NOTICE OF MEETING

1. **APOLOGIES FOR ABSENCE**
2. **DECLARATIONS OF INTEREST (IF ANY)**
3. **CONSIDER NOTICE OF REVIEW REQUEST: 20/0005/LRB - 1 ARGYLL TERRACE, TOBERMORY, ISLE OF MULL (REF: 19/01801/PP)**
 - (a) Notice of Review and Supporting Documentation (Pages 3 - 16)
 - (b) Comments from Interested Parties (Pages 17 - 62)

STATEMENT IN SUPPORT OF THE APPEAL AGAINST THE DECISION OF ARGYLL & BUTE COUNCIL TO REFUSE THE PLANNING APPLICATION FOR THE REMOVAL OF ROOF AND ERECTION OF FIRST FLOOR EXTENSION. LAND AT 1 ARGYLL TERRACE, TOBERMORY.

**REFUSAL OF PLANNING PERMISSION IN PRINCIPLE 19/01801/PP
REMOVAL OF EXISTING ROOF, ERECTION OF FIRST FLOOR EXTENSION
ONTO EXISTING BOTHY TO PROVIDE ACCOMMODATION FOR STAFF
MEMBERS**

10/00039/PP

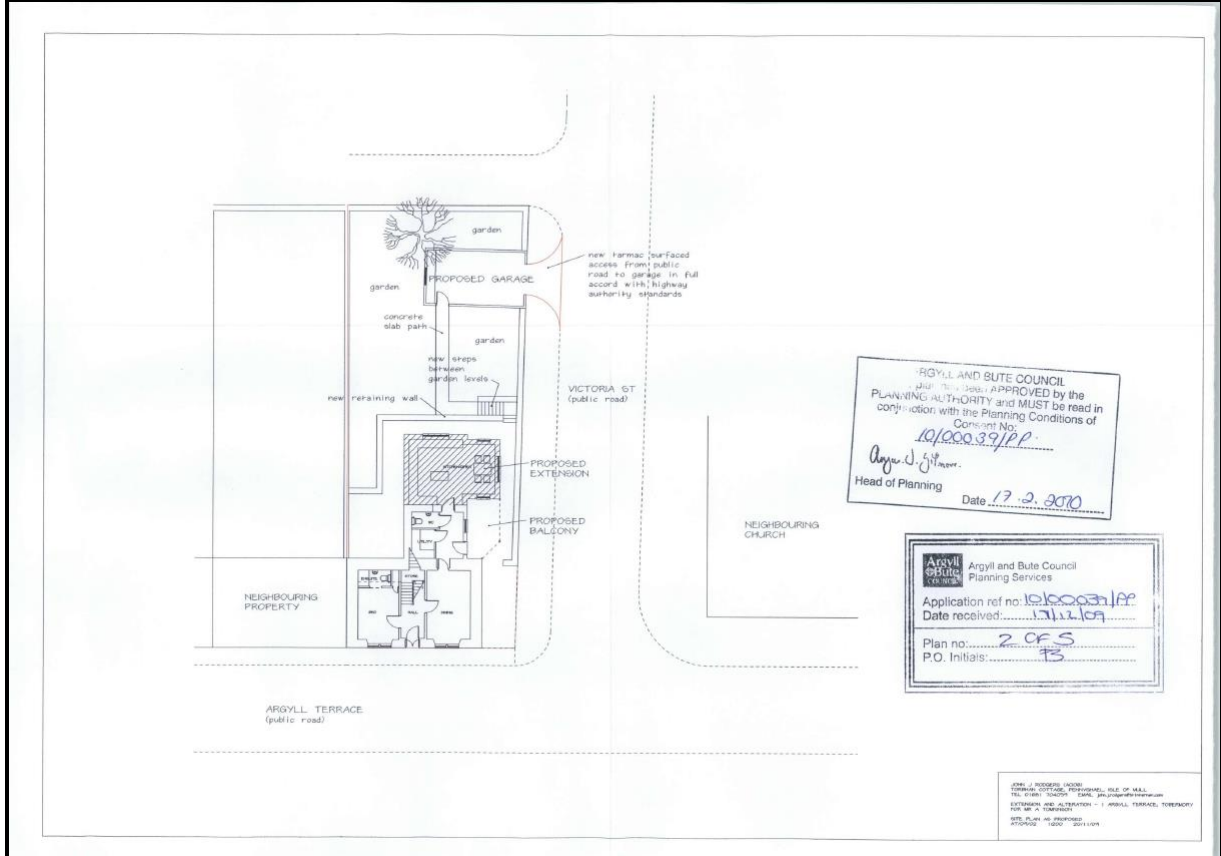
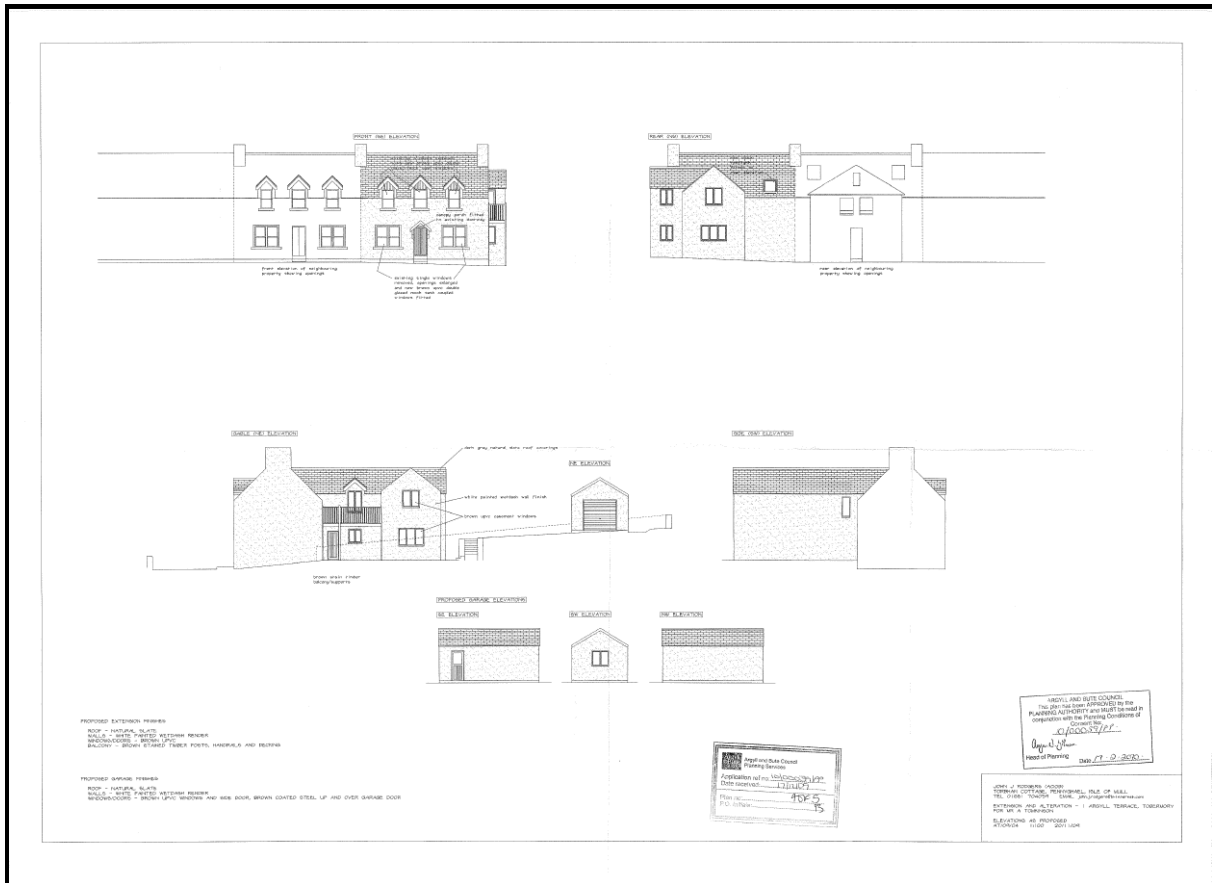
**Alteration and extension to existing dwellinghouse
Granted 17/02/10**

This proposal was for a one and a half storey extension to be built on the rear (west) elevation and a garage to the rear of the garden. The applicant was Mr Tomkinson, the appellant for the current review. This was a substantial extension to the property which, although ultimately assessed as acceptable, clearly affected the former traditional character and scale of the premises to an extent where any further substantial additions would be extremely difficult to justify in terms of landscape impact, impact upon the historic environment and overdevelopment of the site.

It is noted that, at this time, that the applicant asserted that the premises were a single, domestic dwellinghouse.

11/01934/NMA

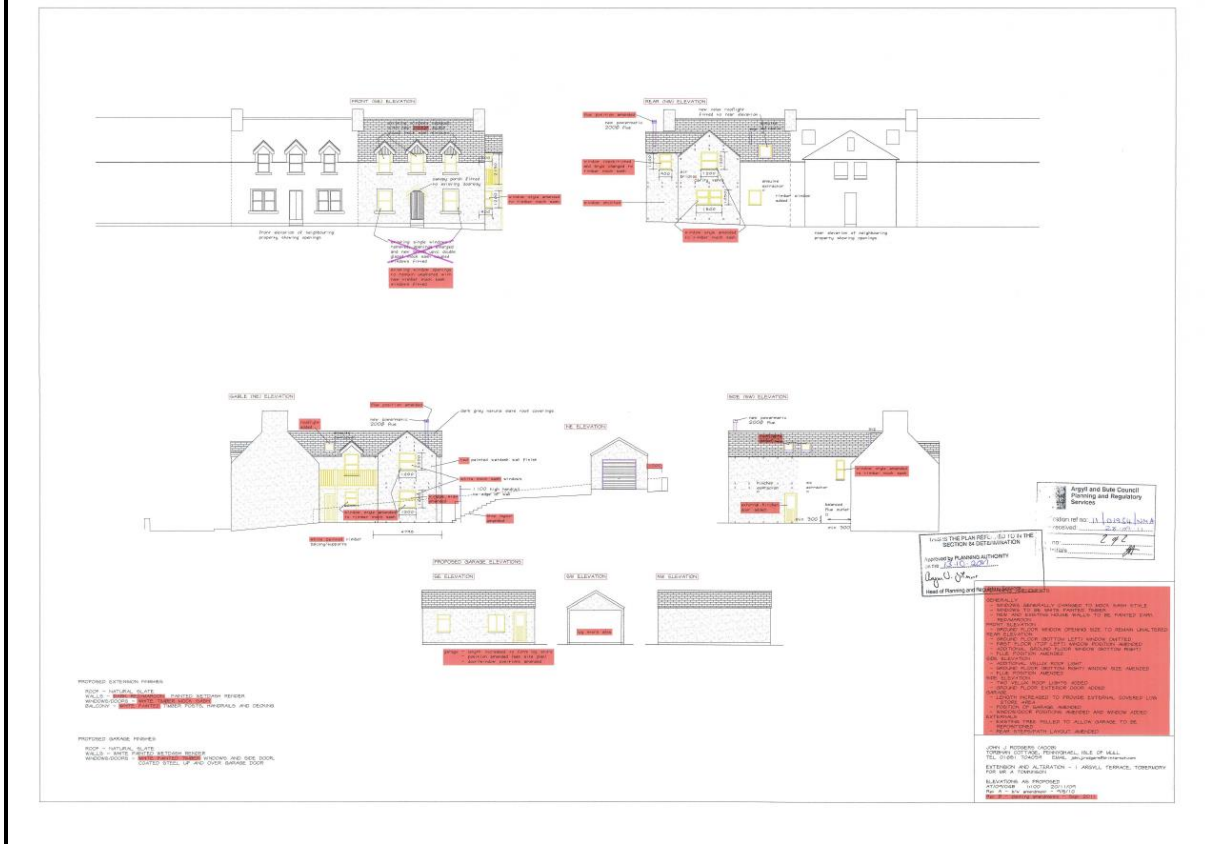
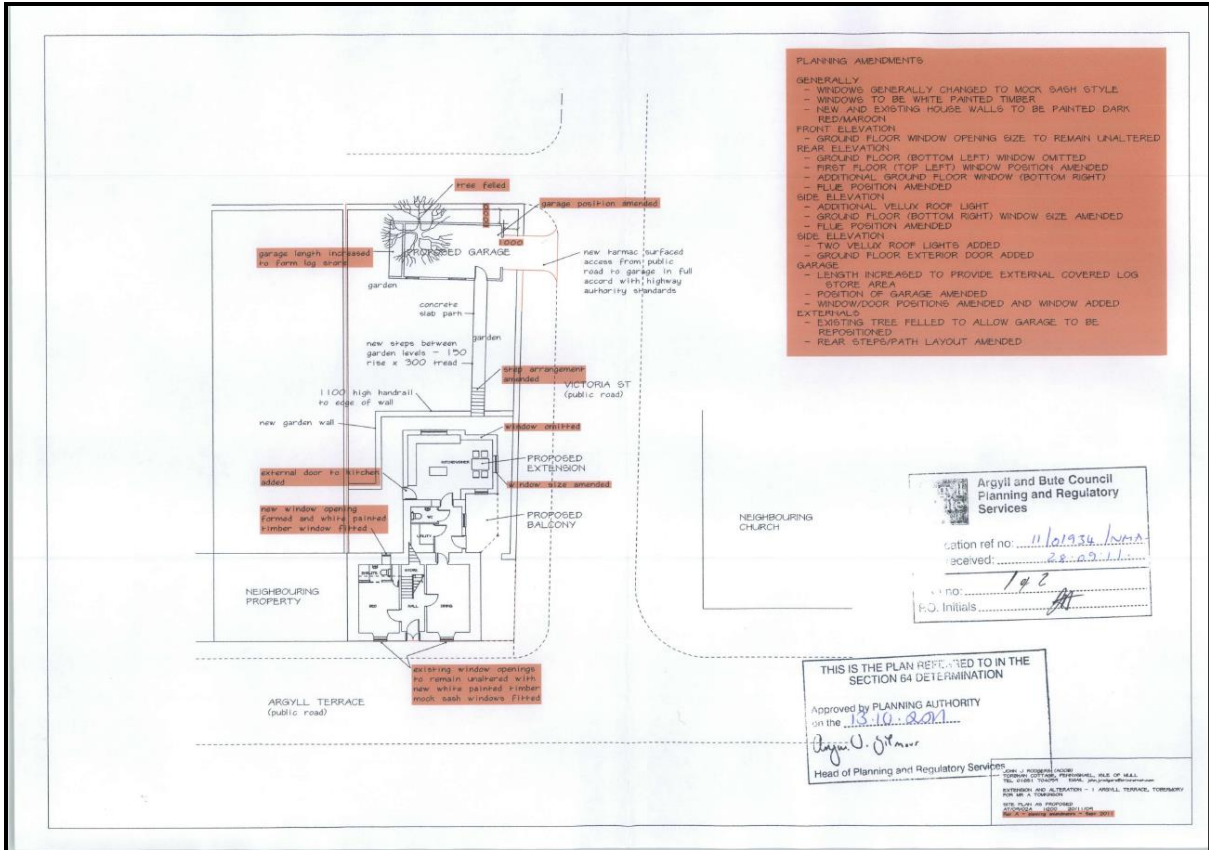
Non-material amendment to planning permission 10/00039/PP - amendment to fenestration, garage siting and finished colour of house. Granted 13th October 2011

This proposal slightly amended the details relating to 10/00039/PP.

13/00338/PP

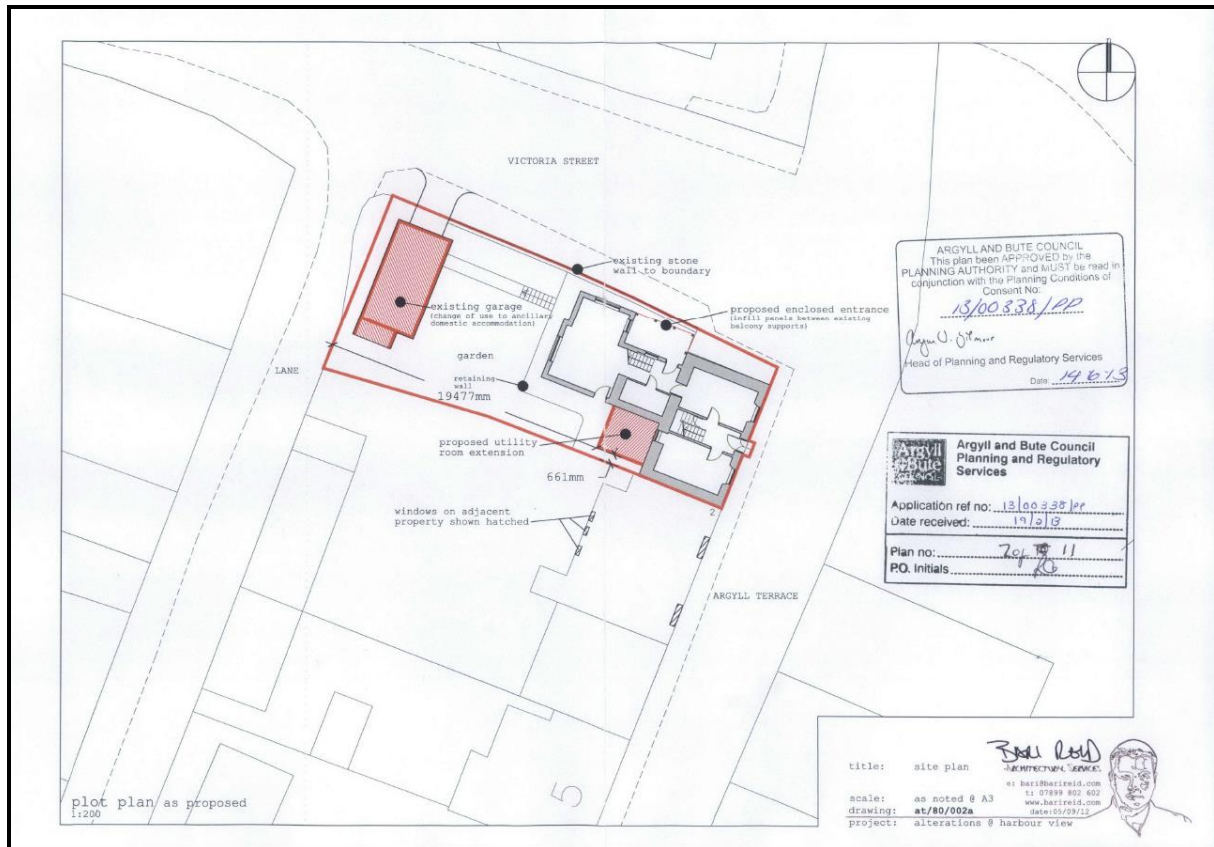
Change of use from dwellinghouse to guesthouse and erection of extensions and change of use from garage to form additional accommodation (retrospective). Granted 14th June 2013

This proposal involved the following:

- Change of use of dwellinghouse to form guesthouse (retrospective)
- Change of use of garage to form additional accommodation (retrospective)
- Erection of utility room extension
- Formation of enclosed entrance

The applicant was again Mr Tomkinson and whilst the works the subject of this application had, in the main, been carried out unlawfully, the planning authority considered at that time that the change of use of the premises from dwellinghouse to commercial guesthouse business, together with the relatively minor utility room extension could be supported. Accordingly, retrospective planning permission was granted.

16/01239/PP

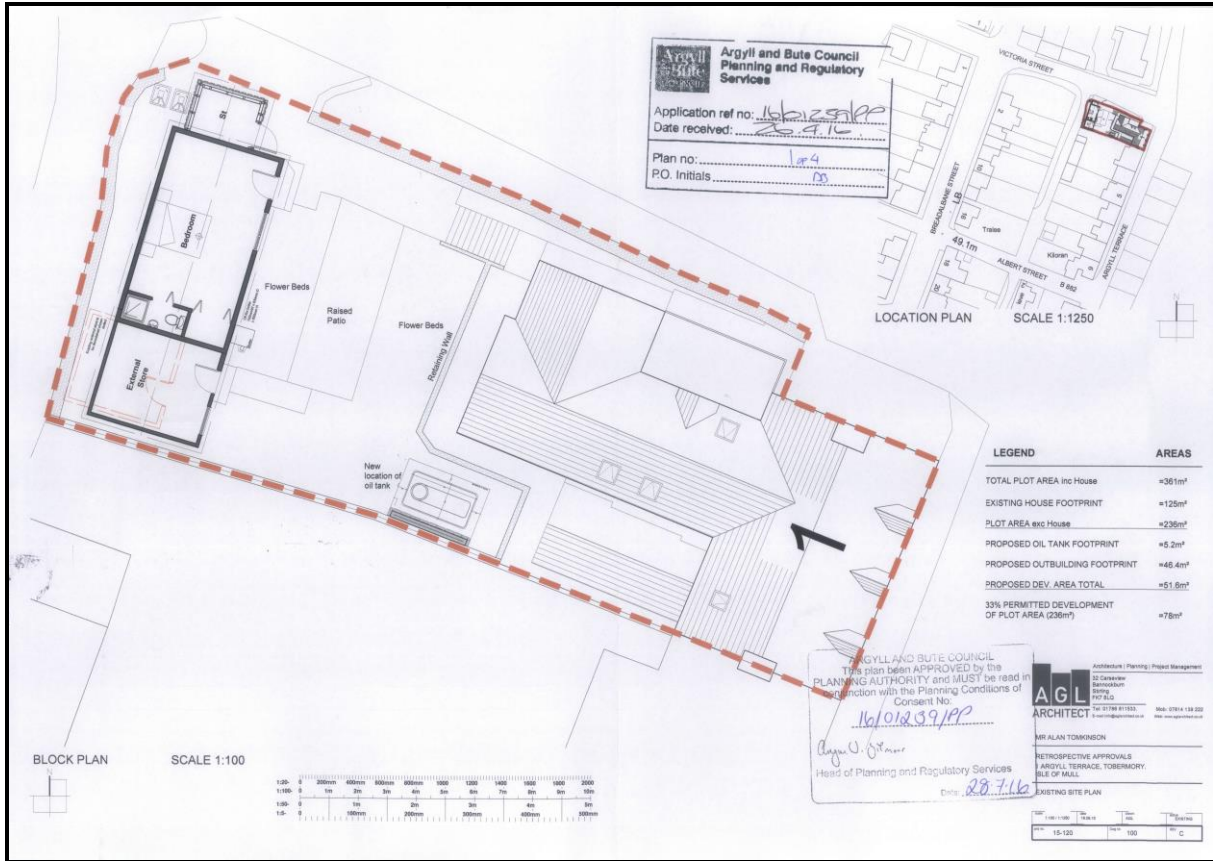
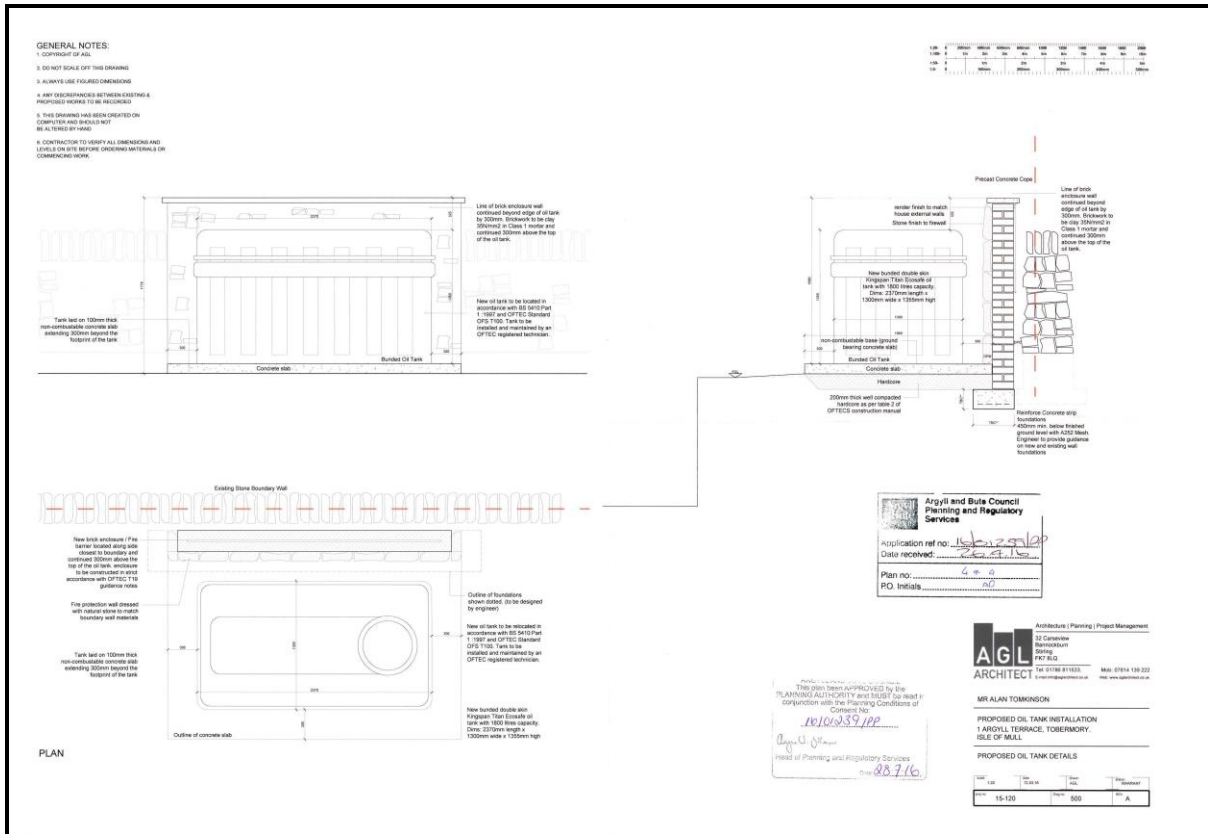
Installation of oil tank and external boiler and erection of extensions to outbuilding (retrospective). Granted 28th July 2016

This proposal involved the construction of a small external store on the northern elevation of the letting unit and a further store on the southern elevation. A new oil tank was also proposed to be erected on the southern boundary with the neighbouring property. These works were carried out in advance of planning permission being granted. There was an existing oil tank which was also unauthorised and this was replaced by the oil tank proposed as part of this permission.

This application was the subject of third party objection which, amongst other matters alleged that the part of the outbuilding at the rear of the garden marked 'external store' on the submitted plans was actually being used as a separate letting bedroom. This allegation formed a subsequent planning enforcement investigation.

Whilst the unlawful works the subject of this planning application again further eroded the character and quality of the conservation area and added to the further built development of what was fast becoming an overdeveloped site, the planning authority considered, at that time, that the development could be supported.

16/02468/PP
Alterations and extension to guest house including roof terrace and repainting of facades of existing building.
Granted 10th March 2017.

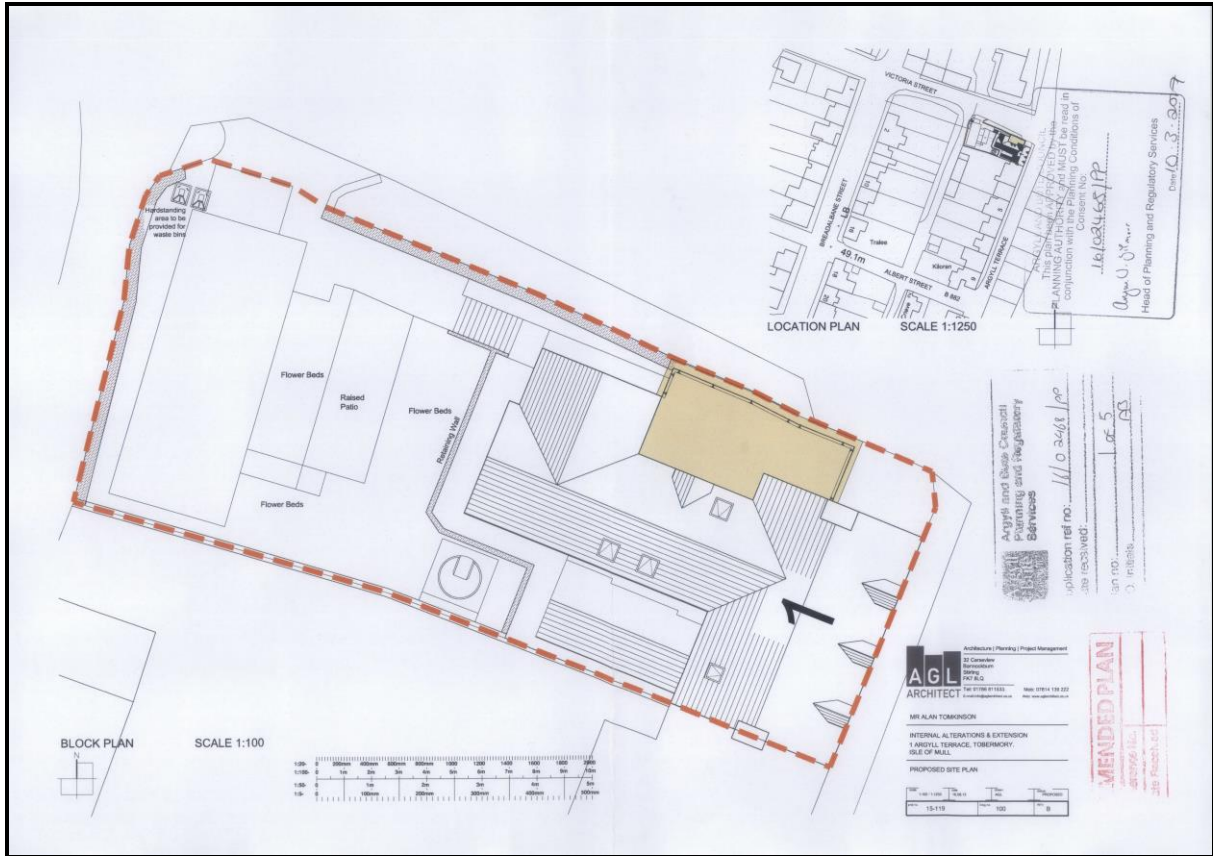
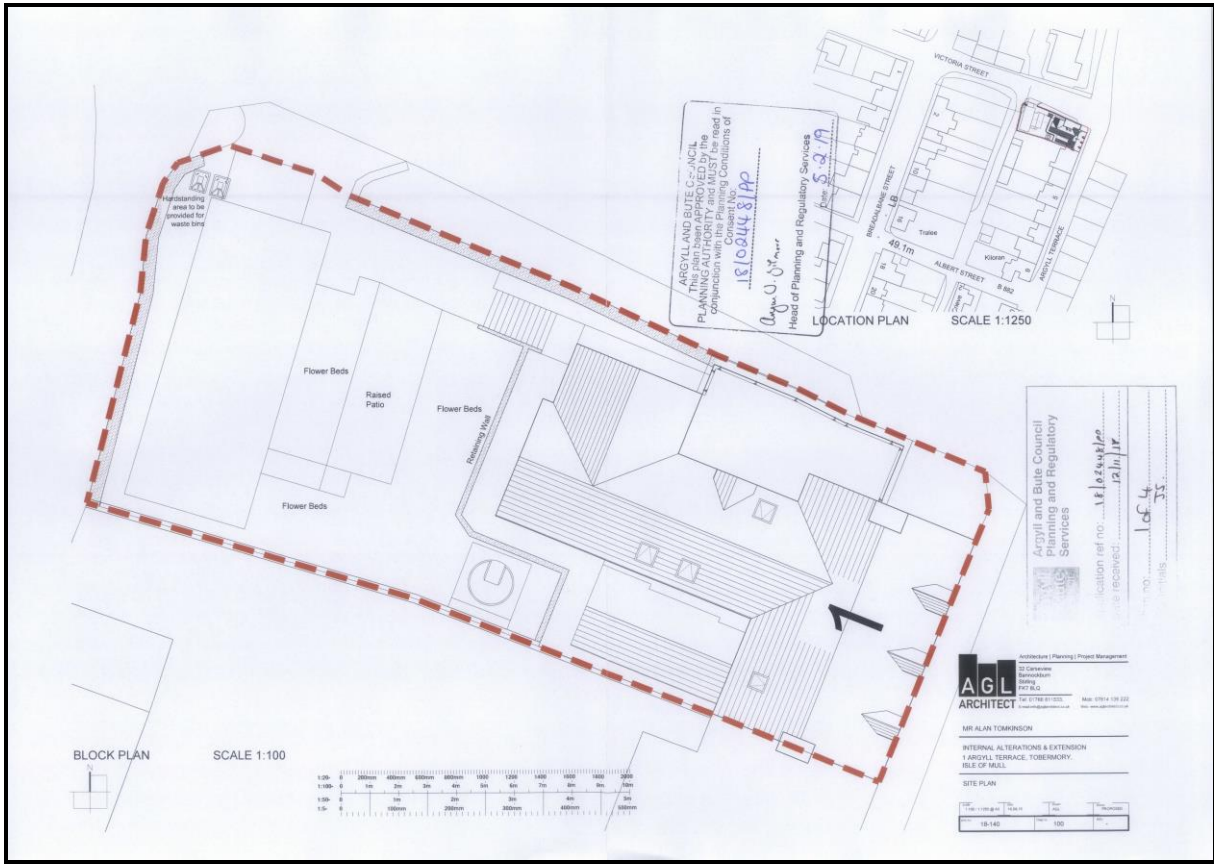
This proposal involved the extension of the property on the northern elevation extending northwards to the existing stone wall and to the east. This provides a new entrance vestibule and space for additional dining tables. The majority of the new floor space created was already covered by an unattractive open balcony. The roof of the proposed extension is the same height as the existing balcony and a new balcony created above.

The proposed development the subject of this planning application whilst again further eroding the character of the conservation area and adding to the bulk of the building and, again, attracting third party objection, was ultimately supported by the planning authority, primarily in order to support the applicant (Mr Tomkinson) and the growth of his business. However, the planning authority were concerned regarding the imminent likelihood of a materially harmful overdevelopment of this site and attached the following informative note to the applicant at this time:

The applicant/developer is hereby advised that the Planning Authority consider it unlikely that any further built development, either by way of extension to the existing buildings within the site, or else the erection of new buildings within the site, would be supported with respect of any future application for planning permission, given the materially constrained nature of the site, specifically the lack of space within it, and its extensive history of previous development.
